We thank the Referee for their comments and suggestions. In the following we answer the Referee comments point by point:

Section 2.1.2 Radiometric Calibration Unit

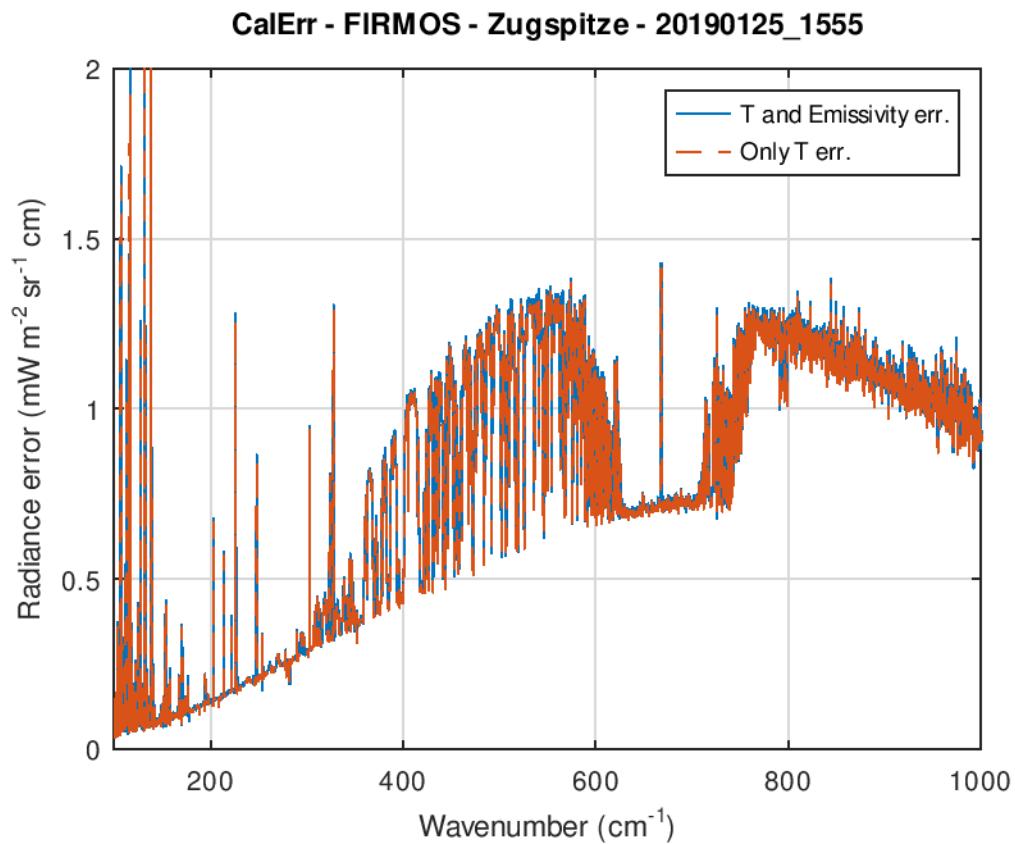
4) The accuracy of 30 mK given in Table 3 is not traceable for me. You state that you use a high-accuracy (30 mK) PT100 sensor as T1, but you do not give an accuracy for the temperature reading by the FIRMOS controller. The accuracy of the Lakeshore temperature monitor is given as 0.6%, which would correspond to 1.8 K at 300 K, which is not very likely and would make this monitor useless to correct for a possible offset of 200 mK in the FIRMOS controller. Please give more details concerning the accuracy of the different sensors and their readout electronics, also for T2 and T3.

The accuracy reported in the original Table 3 is the PT100 accuracy, i.e. only the accuracy of the sensor without the readout electronics. We used the Lakshore monitor to make a comparison between different reading systems of the same PT100 to have an estimate of the total accuracy (sensor+readout)..

(i) the temperature equivalent accuracy of the Lakeshore Model 218 is 68 mK (https://www.lakeshore.com/docs/default-source/product-downloads/catalog/lstc_218_l.pdf?sfvrsn=4a4f54df_7) and not "0.6%"

(ii) the difference of 200 mK between the two readout systems was not "subtracted during the signal analysis" (as erroneously written in the original text) but was considered for the calculation of the total budget of the temperature error.

"Due to the sensor high accuracy, the PT100 is employed to measure the BB temperature value used in the L1 data analysis. The PT100 temperature reading by the FIRMOS controller and by a commercial Temperature Monitor (Lakeshore, Model 218, with a temperature equivalent accuracy of 68 mK) were compared to estimate the contribution of the readout electronics to the accuracy of the BB temperature. The comparison showed a maximum positive offset of 200 mK between the two, this value was conservatively assumed as the BB temperature total accuracy."

Moreover, in Table 3 we changed the script "Stabilization Accuracy" into "PT100 Temperature Accuracy" and we inserted a line with the total temperature accuracy (PT100+readout electronics).

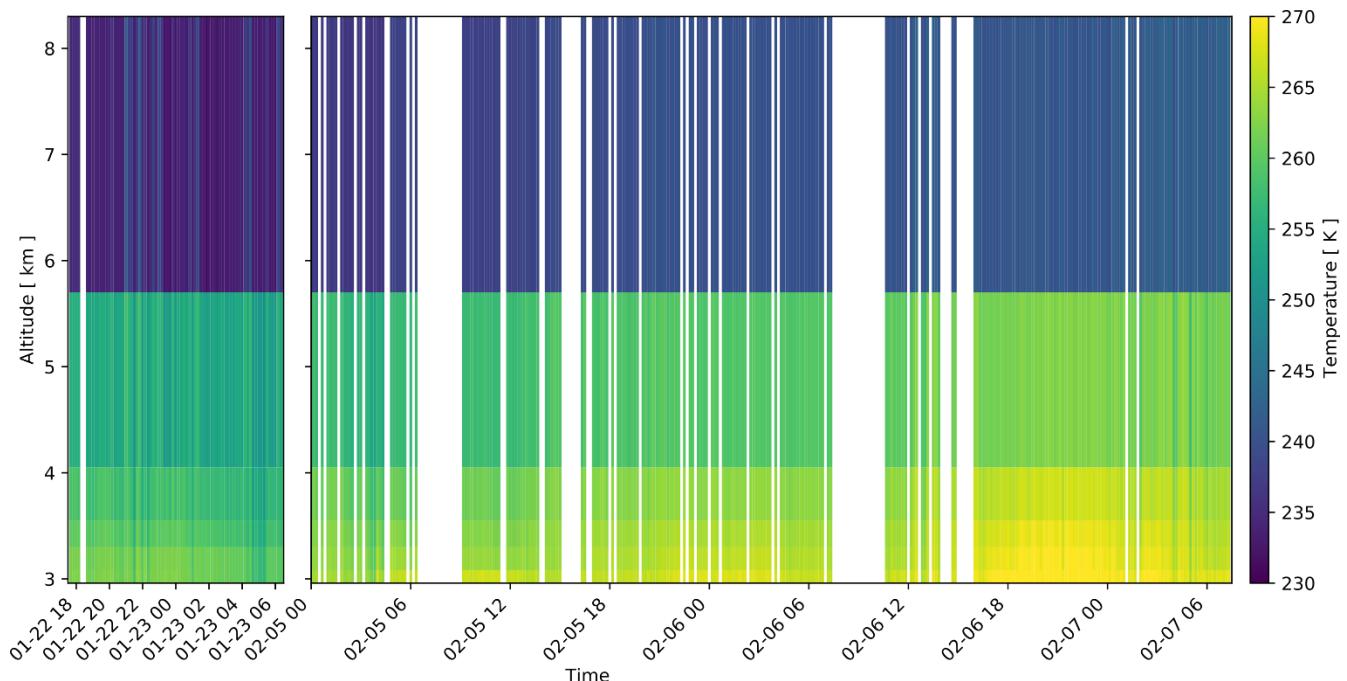
In this section, I find a thorough analysis of the data in terms of fit quality and vertical resolution, but I am missing the data itself, except for two exemplary profiles. Having 625 clear sky profiles in total, it should be possible to provide a meaningful 2D plot as time series (like in Fig. 23) for both water vapour and temperature, when cutting out the times without measurements. This would give an overview over the actual measurements and would allow the reader to comprehend the statement that the variable number of DOFs in water vapour is related to the form of the vertical profiles.

Unfortunately, the data gathered during the campaign is too discontinuous and not dense enough to satisfactorily present the entire dataset. We moved the time-series to section 4.1, the figure is at a higher time-resolution (10 mins) but on the two same periods (22-23 Jan and 5-7 Feb) when measurements were regular enough. The ordinate are now in km as the previous figures.

We removed the qualitative comparison with the ERA reanalysis (see our response to Ref1). The temperature time-series is not particularly informative (see plot below) and we don't think it should be added to the paper.

correlation T DoF vs meanNESR (560-800 cm⁻¹)

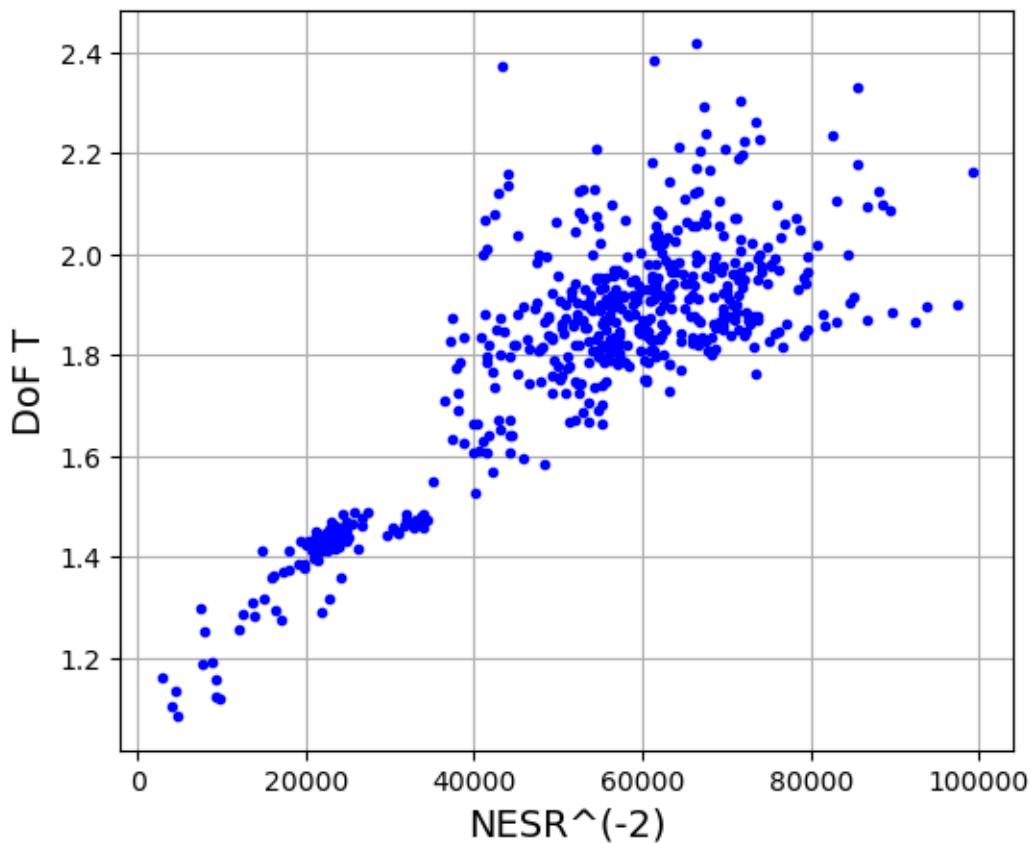
Fig. 14: Also the temperature shows a certain variability in the number of DOFs, although less pronounced than for water vapour. Do you have an explanation for this variation? Is it also related to the actual profile?

We find that the number of DOFs for T is perfectly correlated to the the inverse of NESR (see the following plot).

"The variation in the number of DOFs for the temperature profile is due to the variation of the FIRMOS NESR, indeed, a perfect correlation between the number of DOFs and the average of the inverse of the FIRMOS NESR was found".

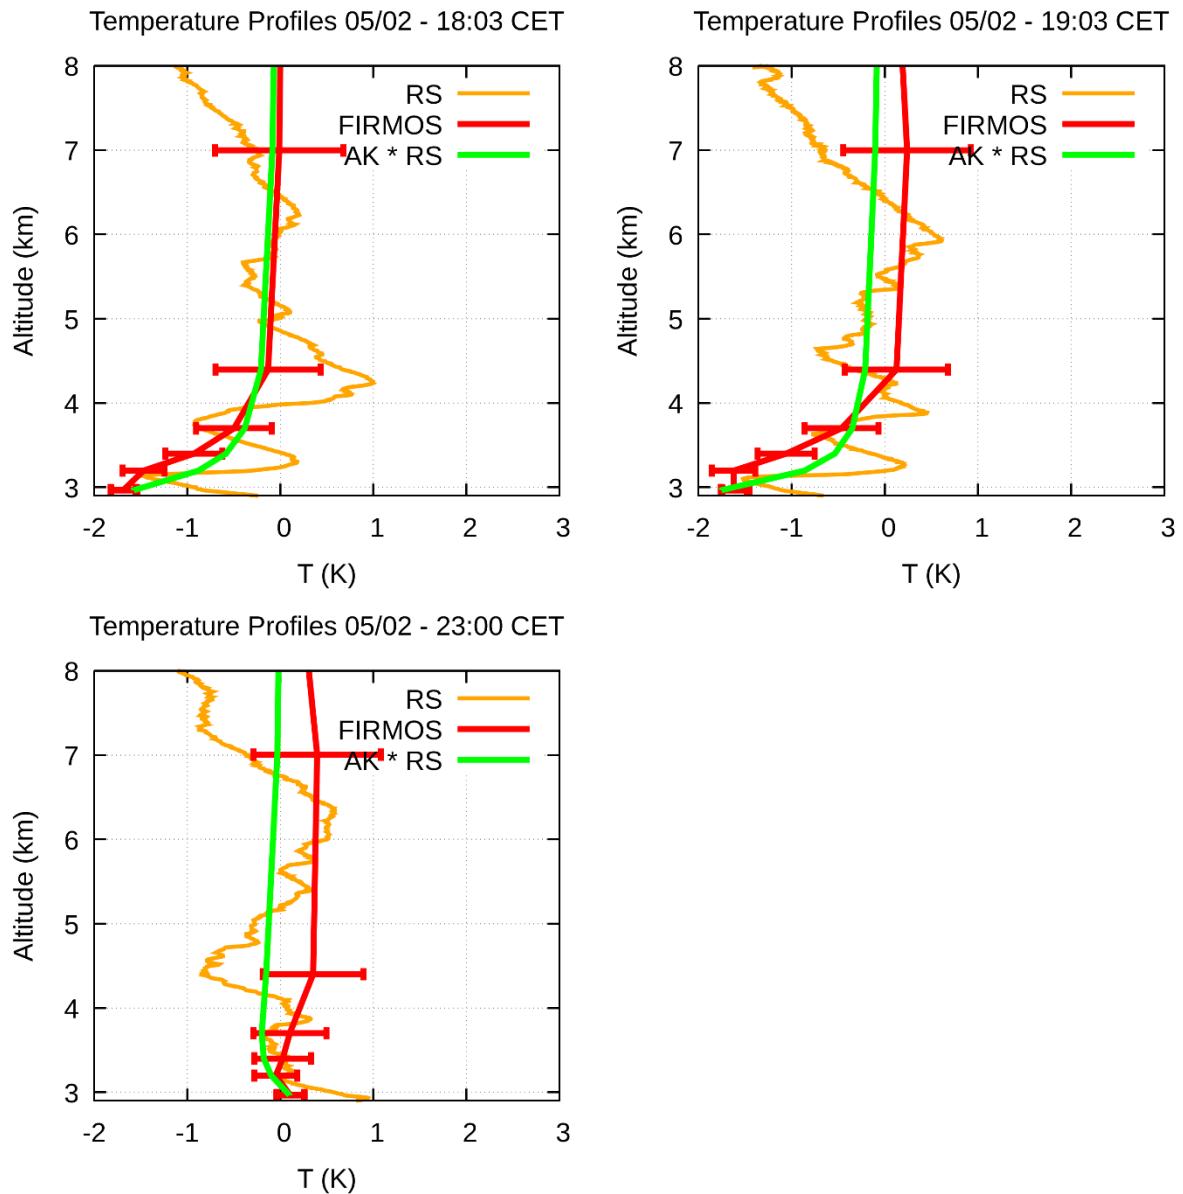
Fig. 20: Difference plots would be helpful here.

The following plots show T profiles as difference wrt the a-priori ($\hat{x} - x_a$).

Referee1 suggested to use skew-T plots here, we think the difference plots are more intuitive, and clearly show the FIRMOS T profile and the AK convolved Radiosonde are within the retrieval error.
